RE: The Mill @ Broadway Phase 2B Expansion Area REVISED (Z17-117)

WALKSacramento has reviewed the revised plans for The Mill @ Broadway Phase 2B Expansion Area (Z17-117). Adjustments made in the revised plans appear to include additional landscaping depth between the entrance doors and the rear walkways of buildings 69 and 70, and greater rear setback and reversed orientation of buildings 66-68. The plans for The Mill @ Broadway Phase 2B Expansion Area continue to disregard elements of five sections of the Northwest Land Park PUD Guidelines that are important for creating a strong pedestrian environment.

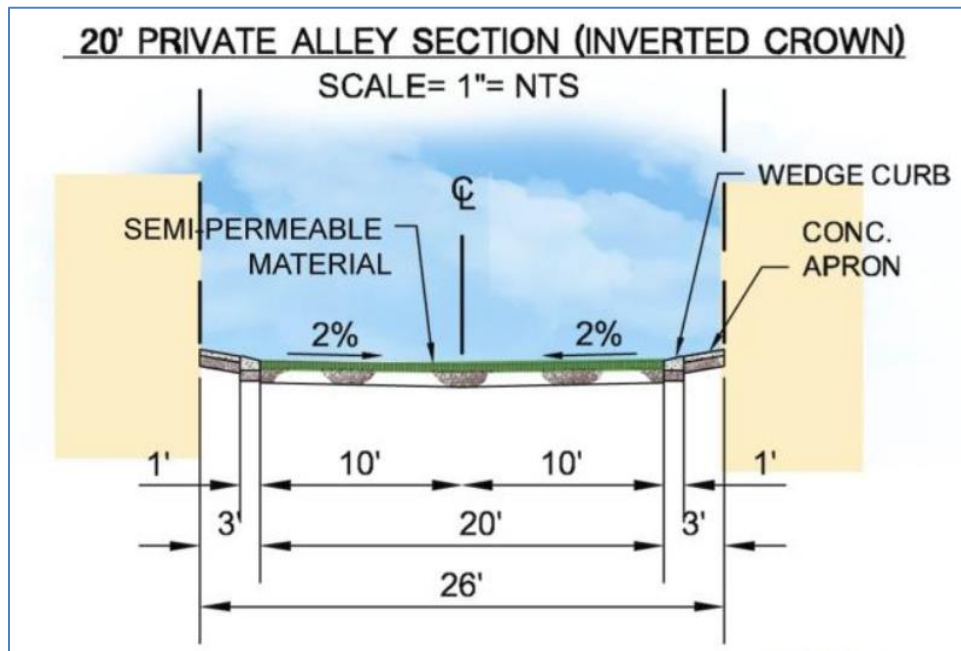
- Residential entrances (effectively front) doors placed out of view from active public or semi-private spaces.
- There are no well-defined pedestrian pathways to the interior duplexes. Below is an illustration in the PUD Guidelines that we've marked up to indicate expected travel ways by pedestrians (blue lines) using courtyards and vehicles (red lines) using alleys.

- The only pedestrian access points to the interior duplex lots is at walkways that connect to the private alleys. The cross section for private alleys, as shown in the PUD Guidelines, anticipates only driveway aprons and not sidewalks. The wedge curb may present an impediment to moving between the walkway and alley for some pedestrians.
